Model: DW2000 MD  
Serial #: See affected models

Product Bulletin # DW-014 Rev 1

## DW2000 MD Splash Protection

Figure 1: Original door design on the left, contaminants trapped in the bottom of the drawworks on the right

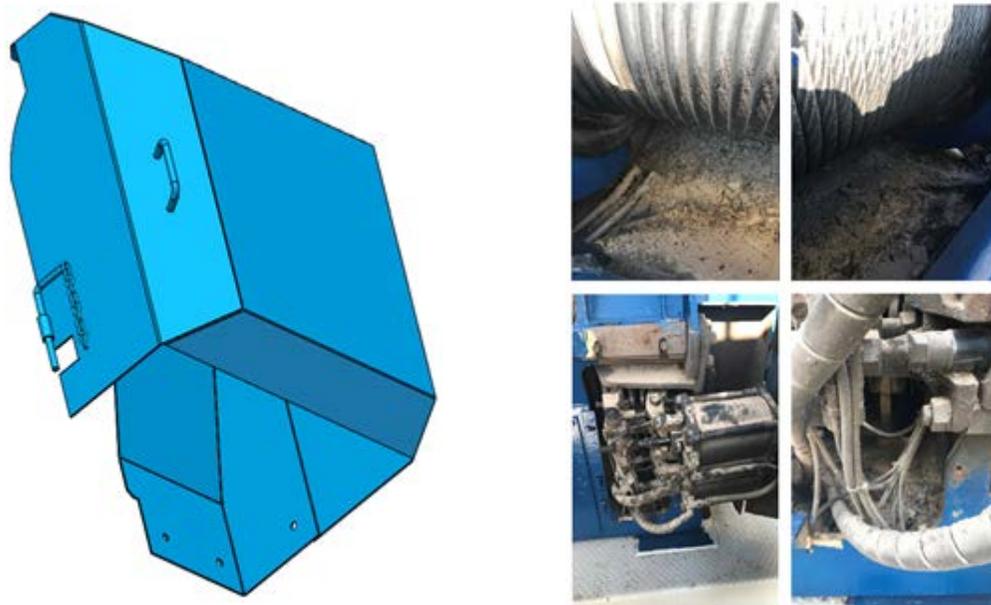
The original guard door design included an open bottom to allow drainage and air flow for the caliper brakes. During field use, it was determined that this design would allow contaminants to enter the base of the drawworks. See Figure 1.

Update the guard doors to include the splash protection and add drain holes to the skid deck. Refer to AY28904 (Figure 3 on page 4) for the new door part numbers and locations for the drain holes.

Figure 2: Updates to existing guard doors

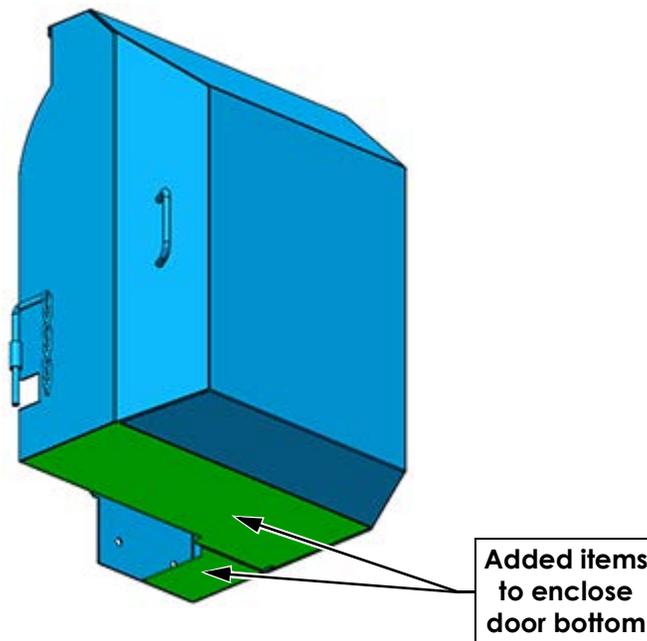
Refer to AY28904 (Figure 3 on page 4) for the procedure for field installation of drain holes on skid. Updated enclosed door to eliminate the ingress of contaminants is shown on Figure 2.
